**Amendment and Response**

Serial No.: 10/679,634

Title: RANDOM ACCESS MEMORY WITH DATA STROBE LOCKING CIRCUIT

**REMARKS**

Fig. 3

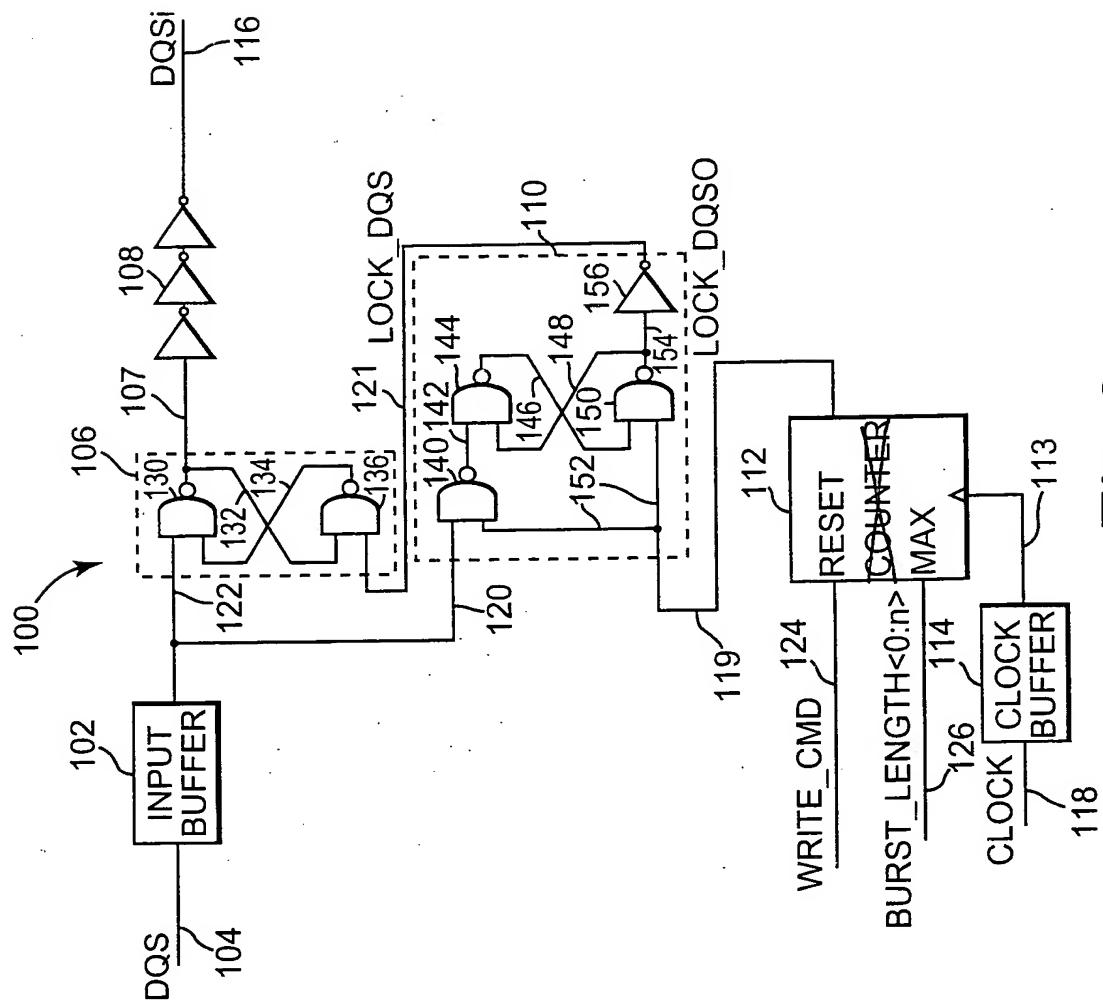
The drawings are objected to because they do not show every feature of the invention specified in the claims. Figure 3 has been amended to remove the “COUNTER” text from block 112. Therefore, block 112 can represent either a counter or a shift register as disclosed in the Specification and Claims. Therefore, withdrawal of the objection to the drawings is respectfully requested.

The drawings have been amended to show a shift register. Applicant respectfully submits that the above rejections under 35 U.S.C. § 112 should be withdrawn.

Figure 3 has been amended as indicated in red in the attached annotated drawing sheet.
